## **Access Compliance Report Public Rights-of-Way** (Curb Ramps)

Intersection ID: 28050 Main Street: TENENCIA\_CT Cross Street: WILLOW\_ROCK\_DR Location: ADA ID: F91C4EA1C27A Ramp Type: PerpDiag Initial Pass/Fail: Fail **Overall Compliance: No Severity Score:** 22.5

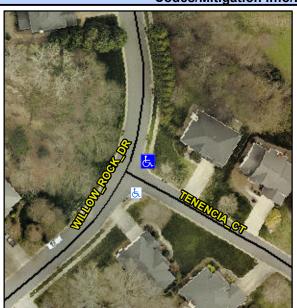
Field Measurements/Component Compliance					
Compliance Description		Data	Comp	liance Description	Data
N/A	Ramp Length (in)	47.0	No	Ramp Slope (%)	11.2
No	Ramp Width (in)	42.0	No	Ramp XSlope (%)	2.3
N/A	Flare Type LT	N/A	N/A	Flare Type RT	N/A
N/A	Flare Slope LT (%)	N/A	N/A	Flare Slope RT (%)	N/A
N/A	Flare Traversable LT?	N/A	N/A	Flare Traversable RT?	N/A
N/A	Landing Length (in)	N/A	N/A	DWS Provided?	N/A
N/A	Landing Width (in)	N/A	N/A	DWS Contrast?	N/A
N/A	Landing Slope (%)	N/A	N/A	DWS Length (in)	N/A
N/A	Landing X Slope (%)	N/A	N/A	DWS Full Width?	N/A
N/A	Landing Curb? (Y/N)	N/A	N/A	DWS Offset (in)	N/A
N/A	Shared Landing?	N/A			
N/A	Gutter Ponding?	N/A	N/A	Gutter Slope (%)	N/A
N/A	Gutter Lip Ht (in)	N/A	N/A	Gutter X Slope (%)	N/A
N/A	Painted X Walk1?	No	N/A	Painted X Walk2?	No
	X Walk 1 Direction	To NW		X Walk 2 Direction	To SW
N/A	X Walk 1 Width (in)	N/A	N/A	X Walk 2 Width (in)	N/A
	X Walk 1 Slope (%)	0.8		X Walk 2 Slope (%)	4.2

X Walk 1 X Slope (%)	3.1		X Walk 2 X Slope (%)	2.5
N/A	Ramp inside XWalk1?	N/A	N/A	Ramp inside XWalk2?	N/A
	Road Slope (%)	1.8	N/A	Clear Space?	N/A
	Road X Slope (%)	4.5	N/A	Clear Space to XWalk (in)	N/A
N/A	Any Obstructions?	N/A	N/A	Storm Grate/Utility Hazard?	N/A
	Obstruction Type			Storm Grate/Utility Type	
		N/A			N/A
			Yes	Surface Condition? (G/P)	Good

Possible Solutions: Remove & Replace Curb Ramp With **Two New Directional Ramps or** Equivalent. Surveyor Notes: N/A PROW/ADA: R304.5.1, R304.2.2, R304.5.3
